TOWN OF EXETER, NEW HAMPSHIRE

**TOWN OF EXETER
PLANNING DEPARTMENT MEMORANDUM**

Re: Definitive Subdivision Submittal for 100 Linden Street
WAIVER REQUEST

Town Planner Comments

**DETENTION BASIN  
PROFILE VIEW**

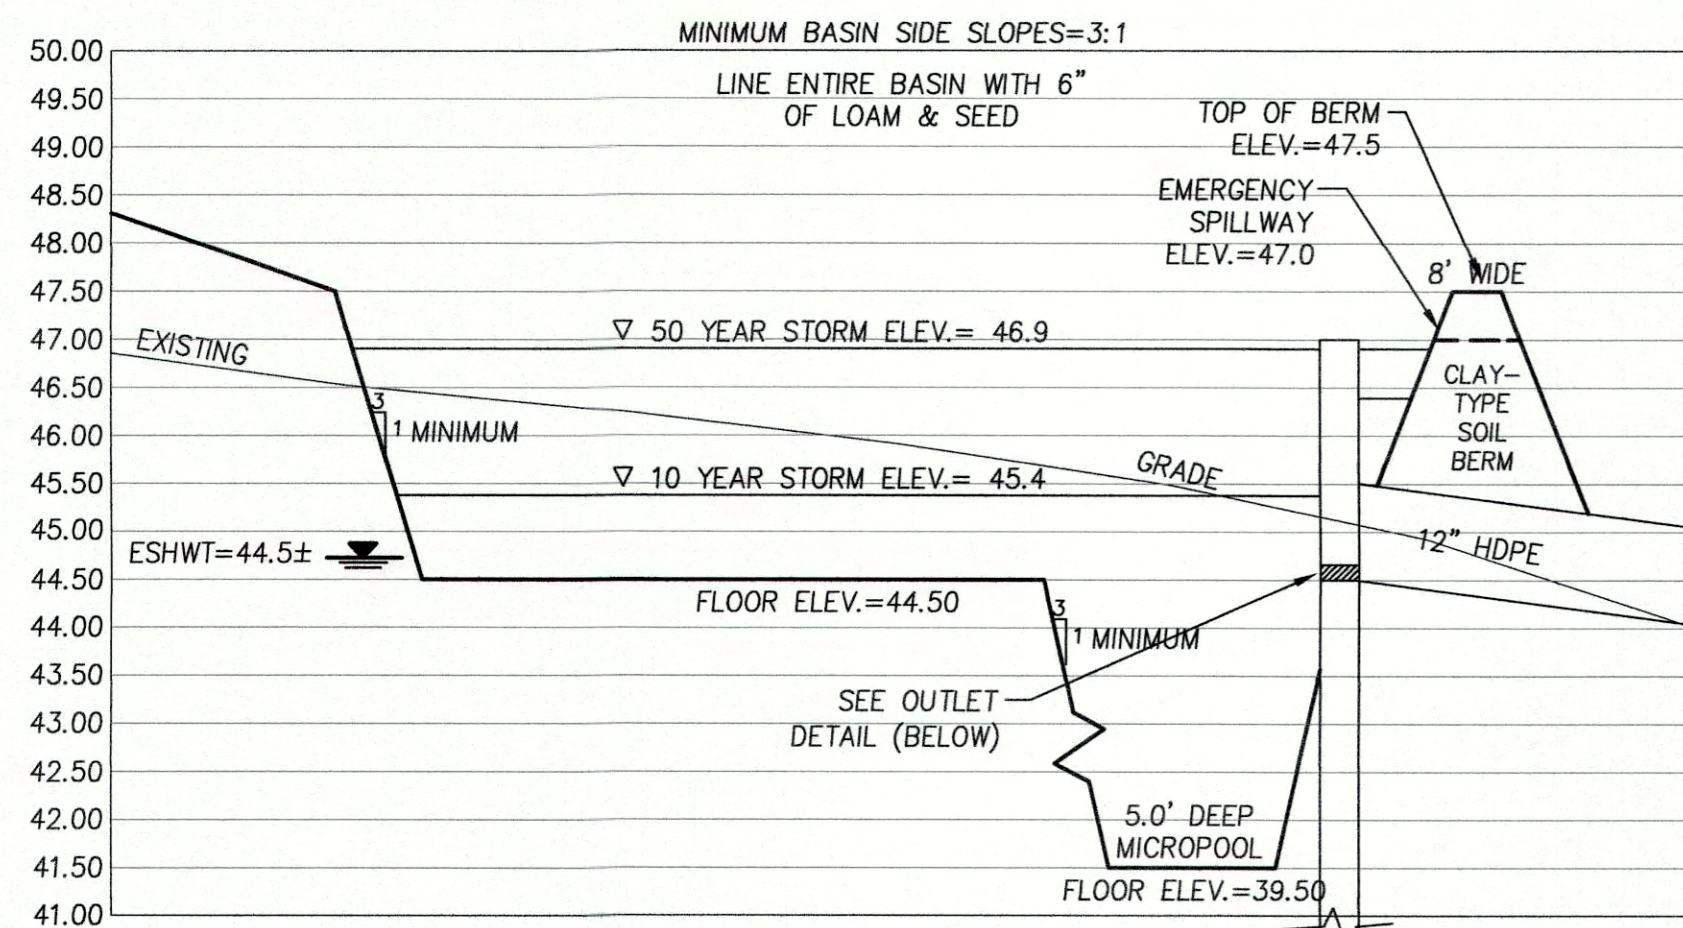
17. Detention Basin Profile View and Outlet Structure Detail: *The following comments pertain to the Detention Basin Detail and the Outlet Structure Detail:*

- *Clarification is needed on why the 10-year storm elevation (44.4') is below the ESHWT (44.5').*
- *It is understood that the Outlet Structure detail is not drawn to scale, however it should be drawn proportionally to avoid confusion during construction.*

Response: The Micropool Extended Detention Pond is designed per the NH Stormwater Manual (refer to the attached BMP worksheet in the Stormwater Report, Appendix E). The "flood" elevations have been renamed to "storm" elevations. Maintenance note 2 has been removed. It was an outdated note. The orifices have been changed from (2) 0.5" orifices to (1) 1" orifice. The inlet elevations of the outlet structure have been revised to be above the ESHWT. The 10-year storm elevation is now higher than the ESHWT. The outlet structure detail has been revised accordingly.
